**RE: Response to EPA Comments on the Scope of Work for Limited Delineation and Verification Soil Sampling and Monitoring Well Installation
Clean Harbors Kansas, LLC
2549 New York Street, Wichita, Kansas
EPA Identification No: KSD007246846**

This letter provides responses to your December 28, 2004 comments on the document referenced above. U.S. Environmental Protection Agency (USEPA) comments are reproduced below in normal text, followed by the response in italicized text. The revised scope of work is provided as Attachment A.

**Revised Scope of Work for Limited Delineation and
Verification Soil Sampling and Monitoring Well Installation**

FIGURE 1

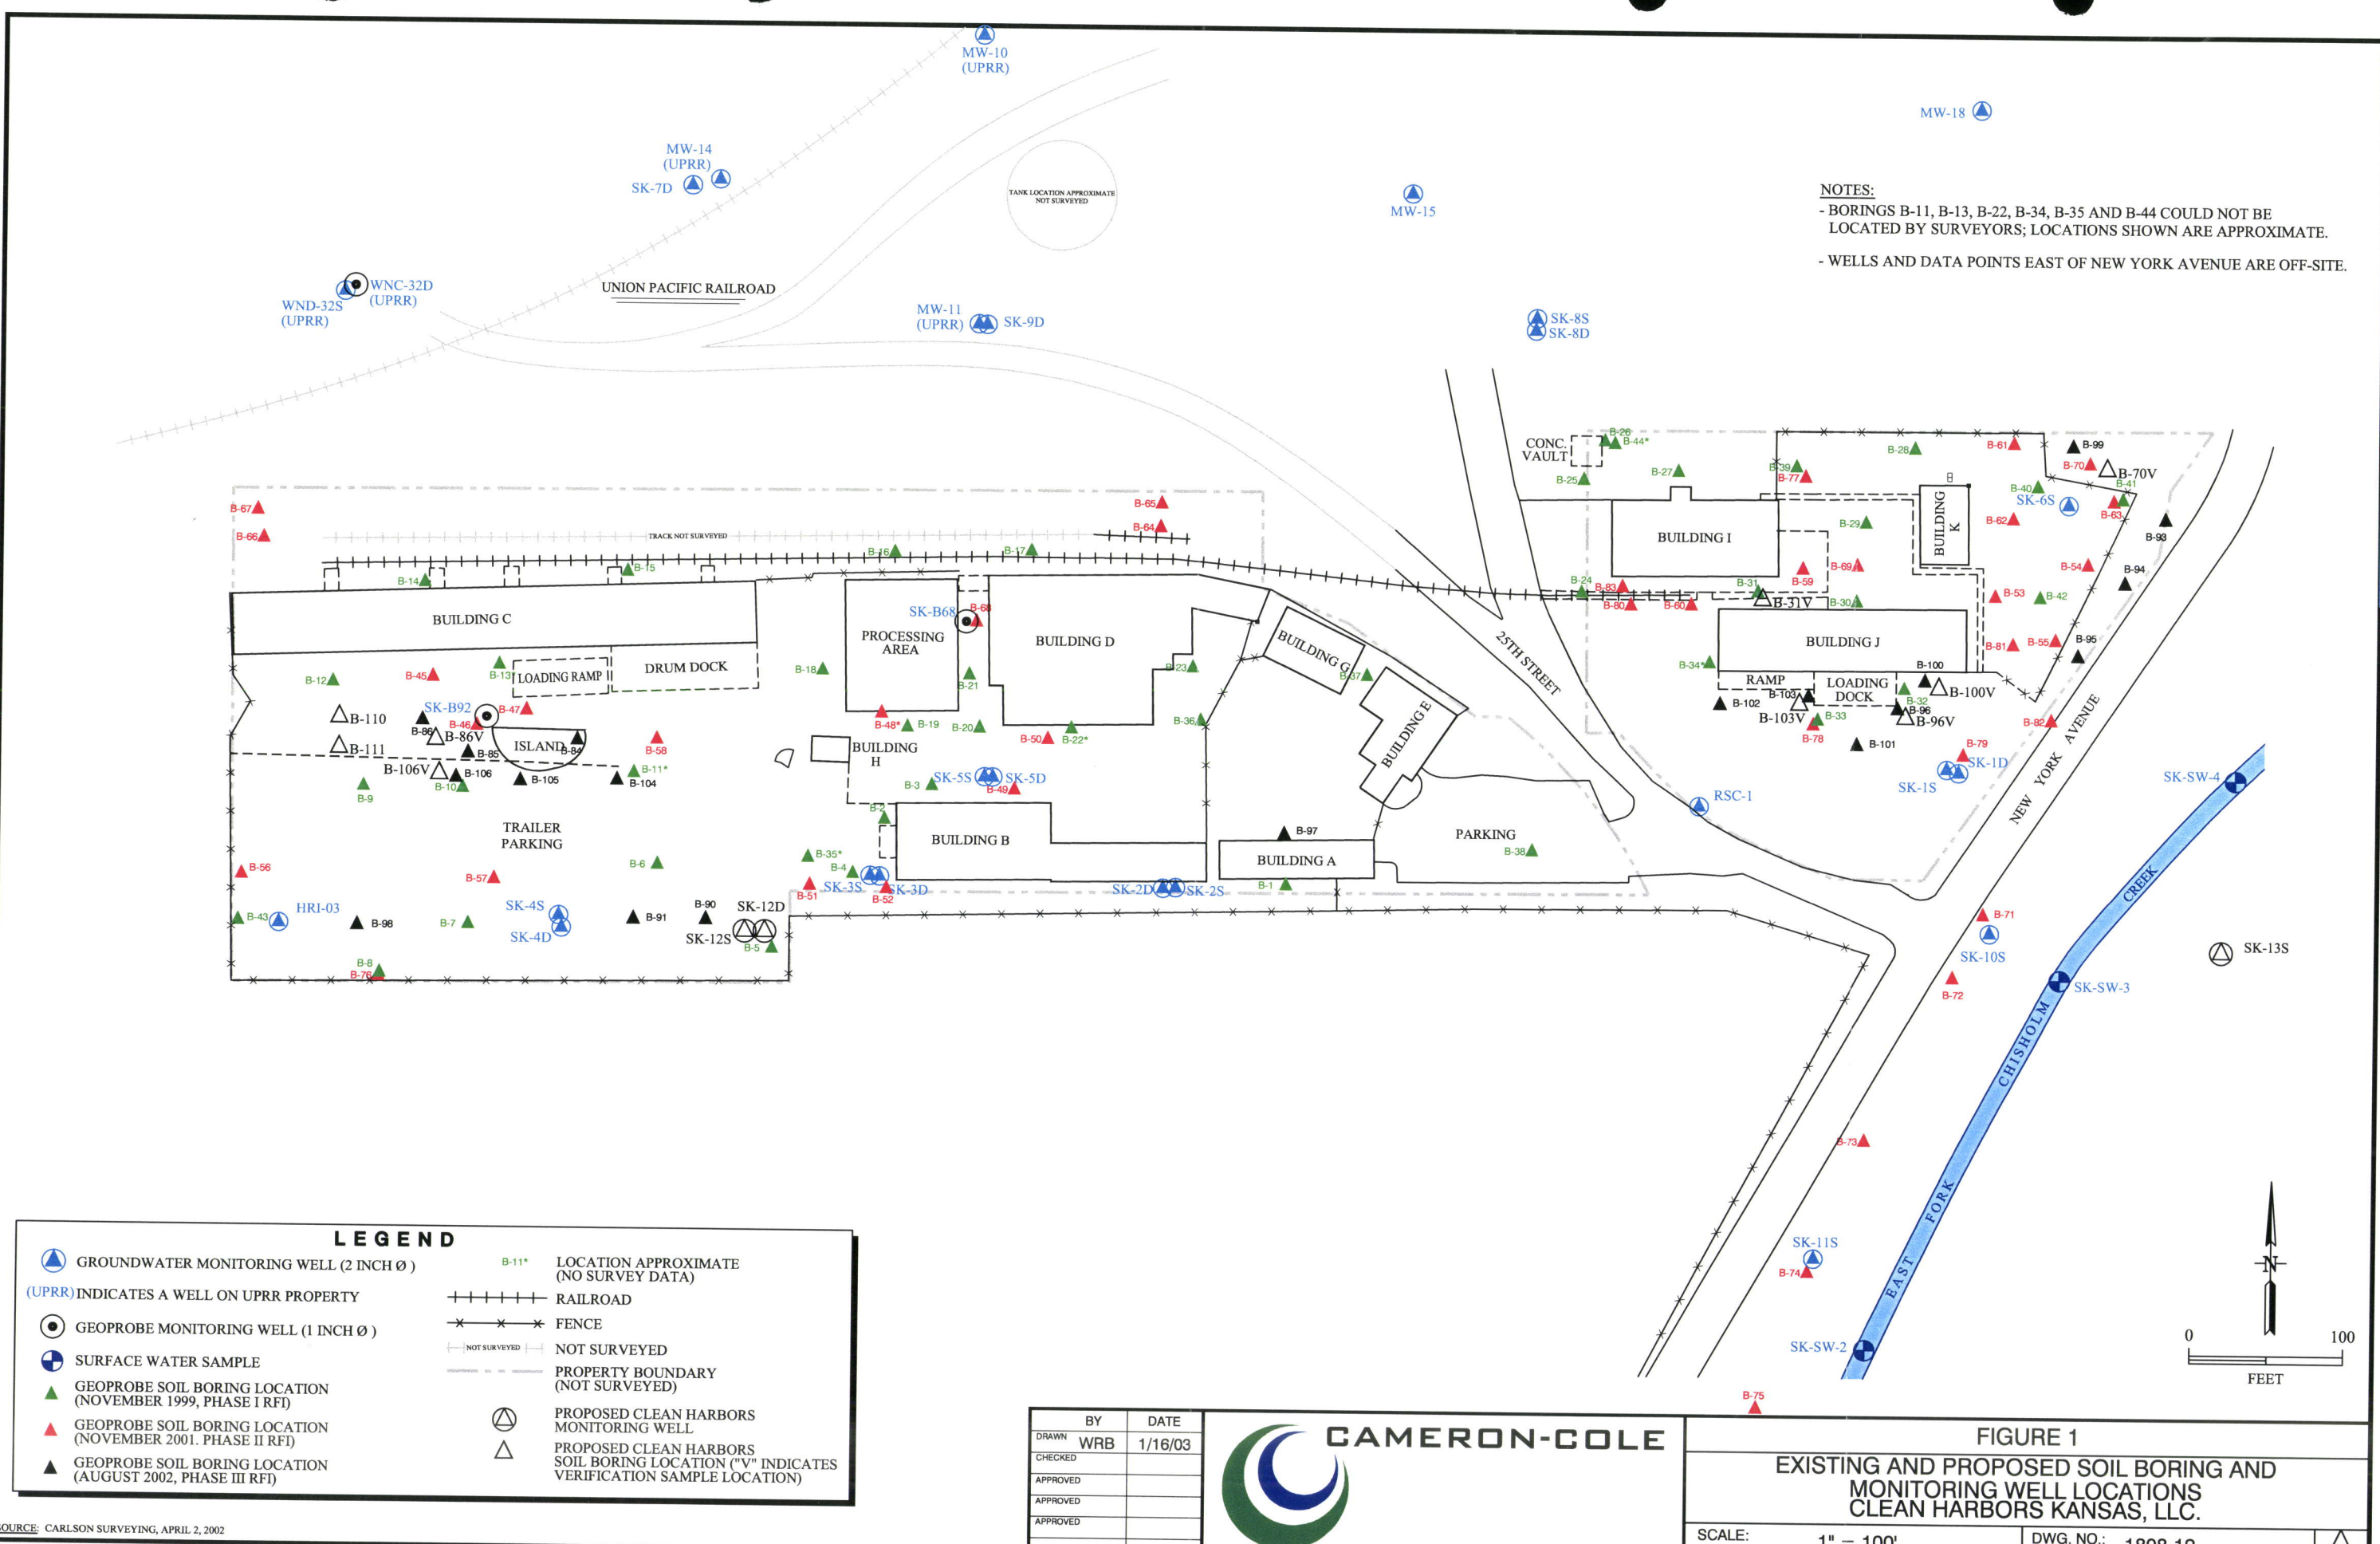
- A. Additional VOC verification samples from the Solids Gondola area to demonstrate correlation with some of the higher VOC results obtained on-site.

- B. One sample to verify results of the data from B-70 or B-99. These samples were collected outside the fenceline; additional samples should be completed for the purpose of ensuring that there are no uncontrolled exposures.

Response: *Clean Harbors has revised the referenced scope of work to include the collection of two verification soil samples from previous boring locations B-86 and B-106.*

Response: *Clean Harbors has revised the referenced scope of work to include the collection of two verification soil samples from previous boring location B-70.*

The soil sampling locations identified in the above responses were agreed on in a telephone conversation with USEPA on January 5.
